Document Title	Park Inn Manchester Heat Pump – Planning Conditions Justification
Document Number	P0684-PSK-XX-XX-P-M-26601
Revision	P01
Prepared By	Andrew Hodgson
Checked By	Richard Stone
Date	07/05/2025
Purpose	S4 Suitable for Stage Approval
Project Stage	Stage 5

Radisson Park Inn Manchester Heat Pump - Introduction

6. BMS Controls Screen Shots showing time schedules

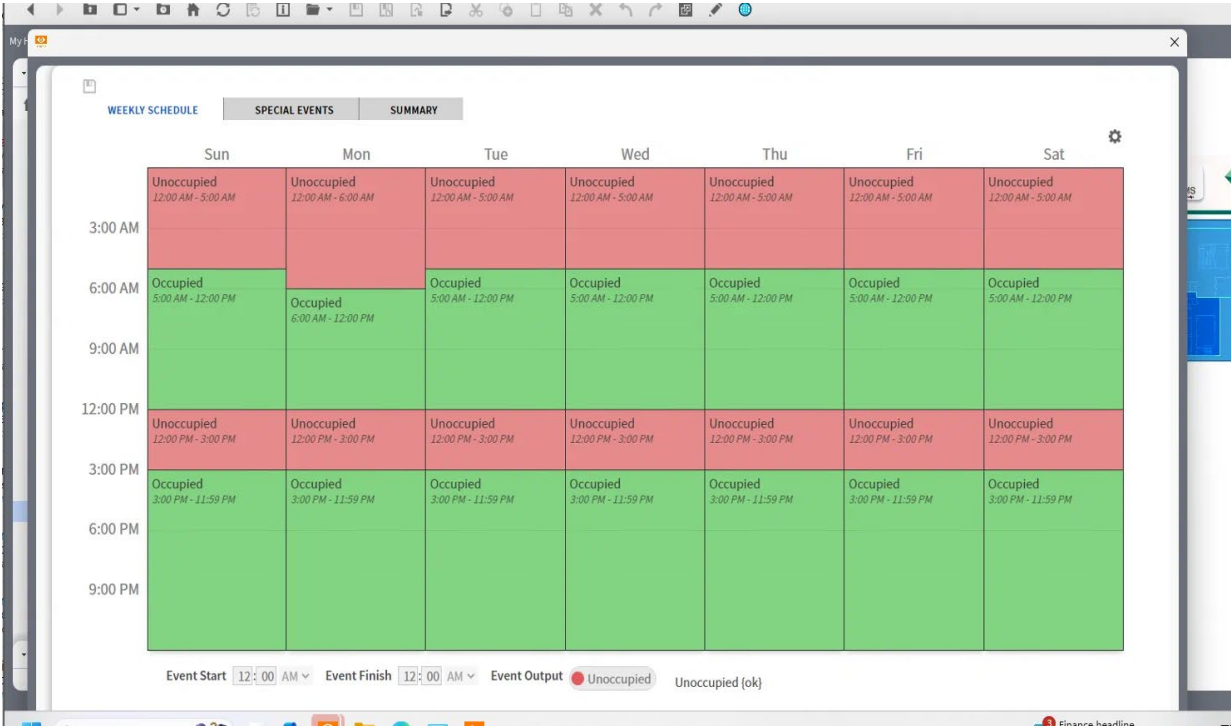
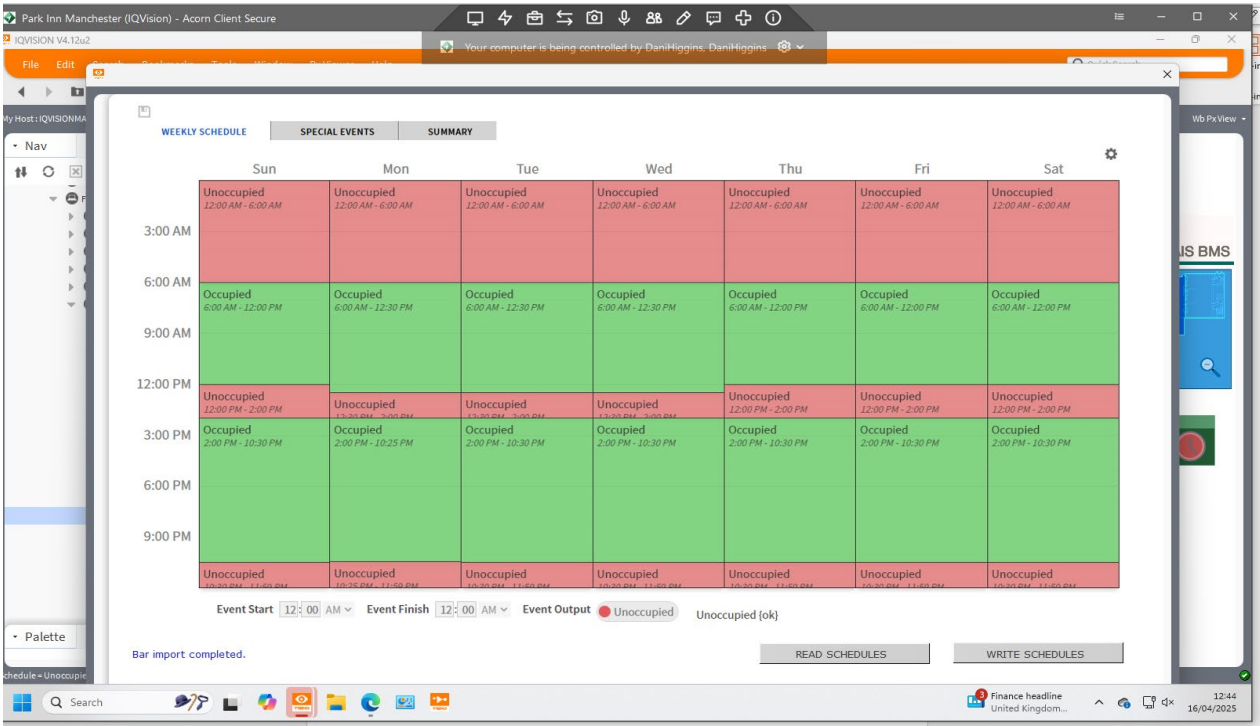
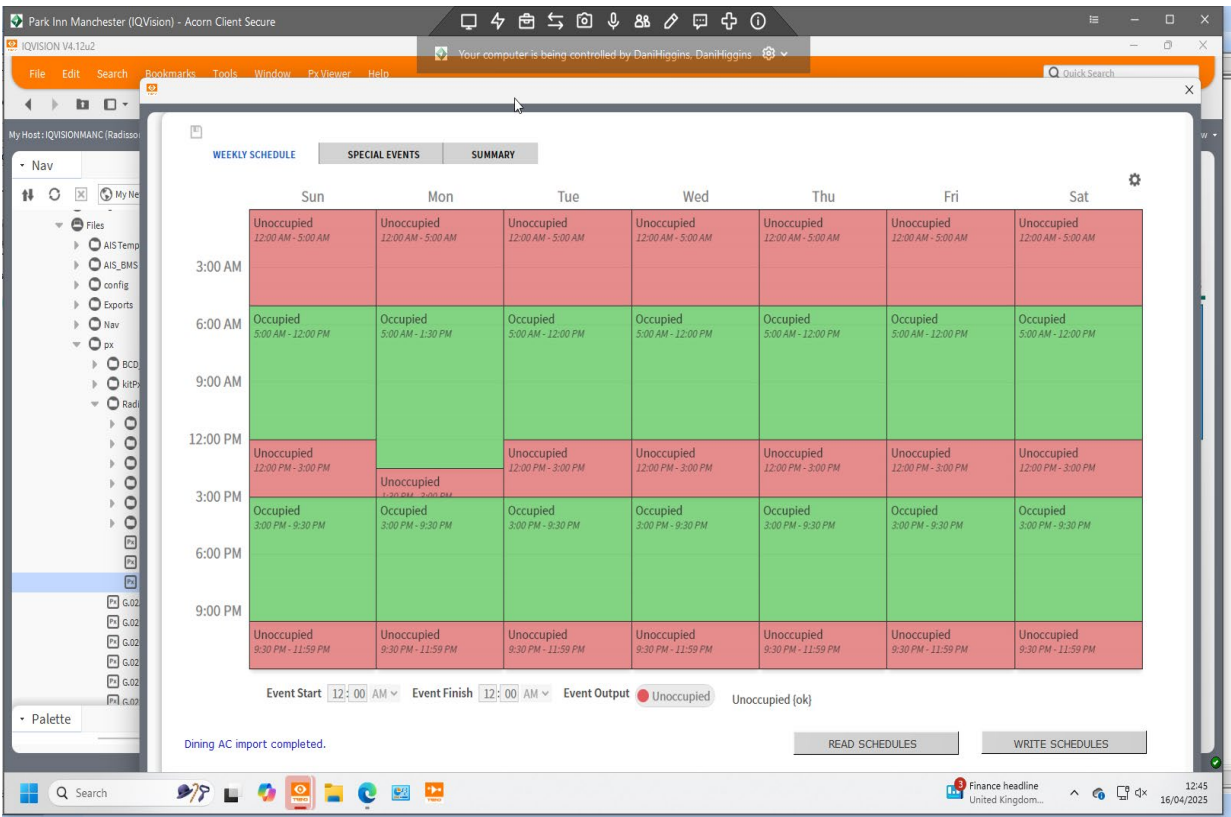
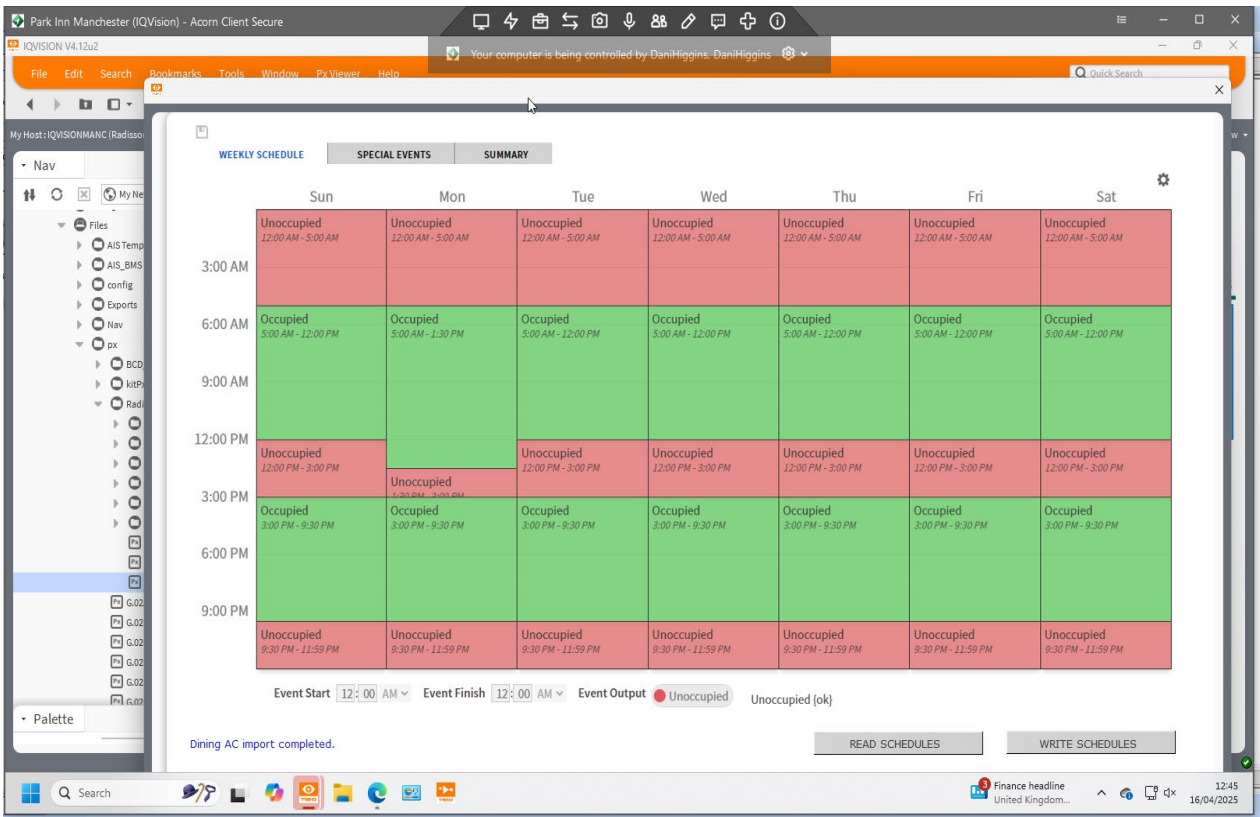
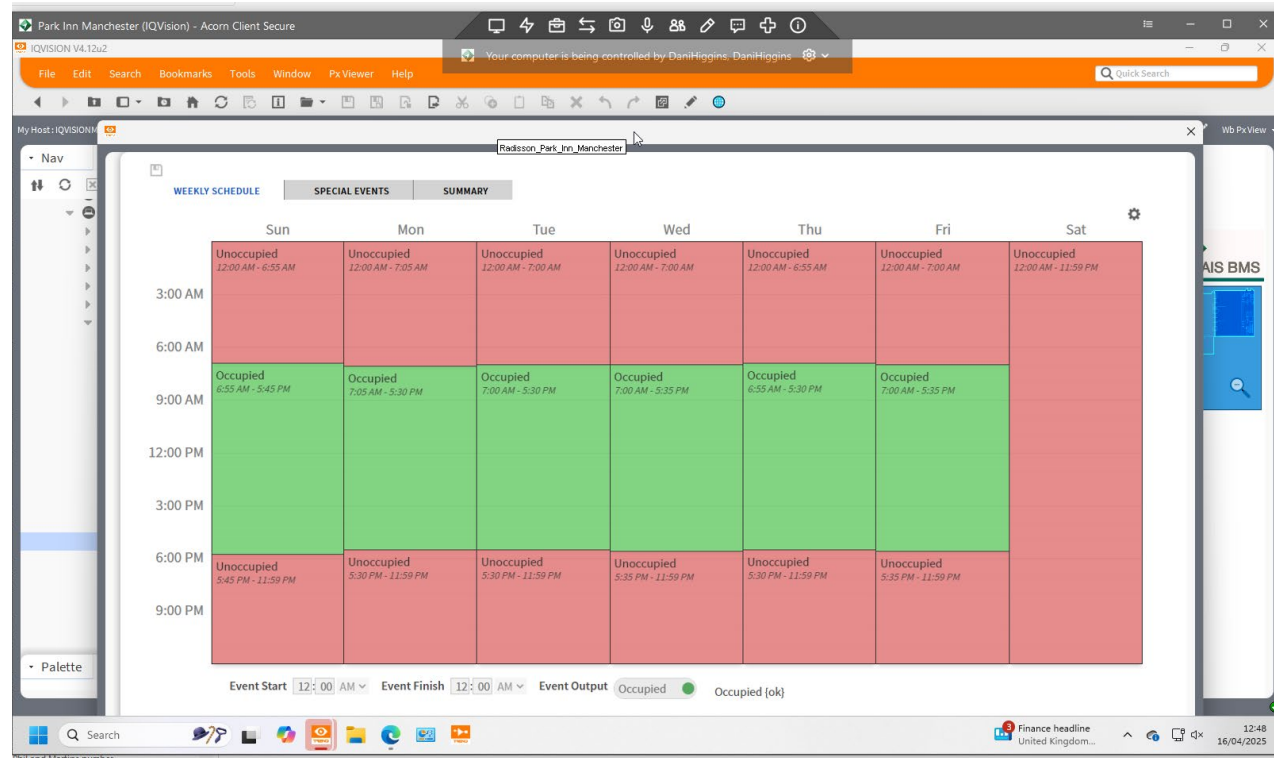
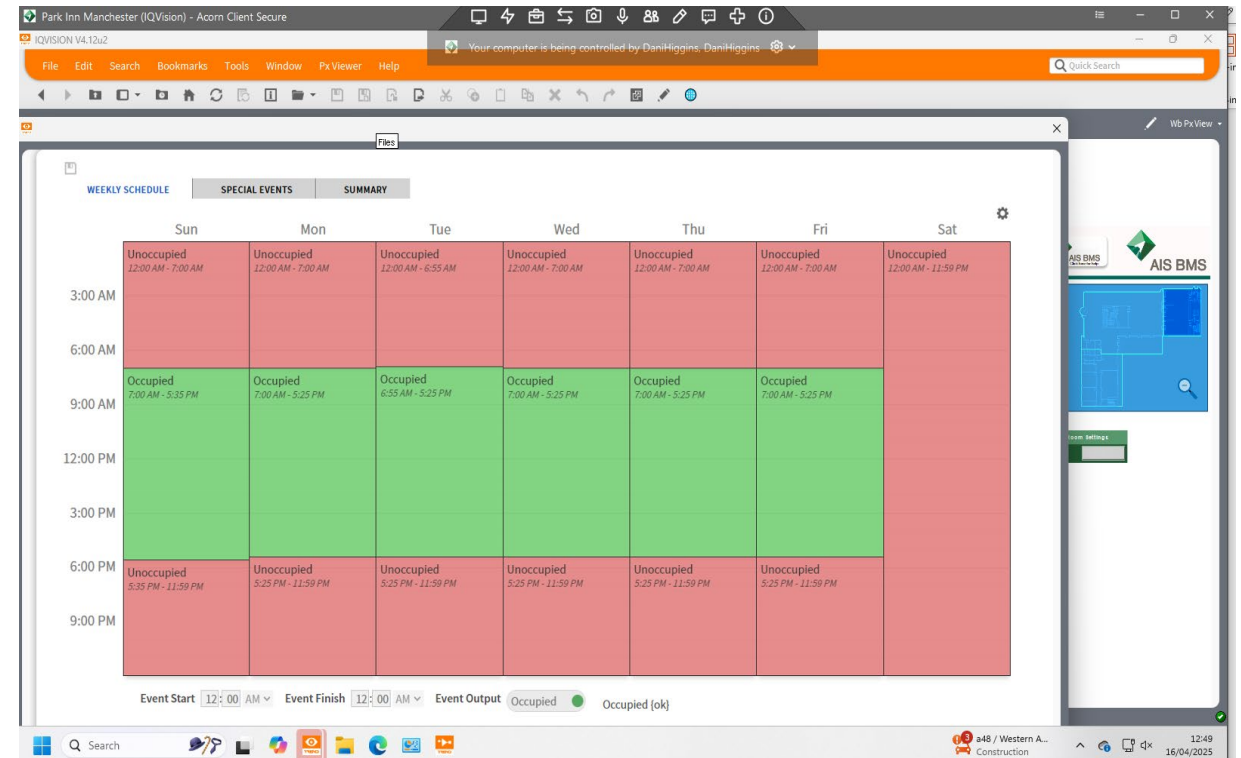
to The report advises that the plant will operate at 50% of design duty during the night and only 50% of the AC units will operate during the night. We will need confirmation from the applicant and heating engineer / building management that this is the case and how this will be controlled not exceed this duty and unit operation as the assessment has been based on this reduced load during the nighttime hours .

Please refer to the screenshots of the existing building management controls system demonstrating the Air Conditioning systems serving the Hotels front of house areas such as the Ground floor Bar and Restaurant and Conference Centres are non -operational during unoccupied hours i.e. during the night therefore no external plant noise is generated by this equipment.

The Above Screenshots show the unoccupied time zones for the conference meeting rooms and the existing AC Systems to be made non-operational during these times.

The Quantity of the systems serving the front of house areas equates to 50% of the total Air Conditioning Systems therefore 50% of the existing systems are nonoperational during the nighttime hours.
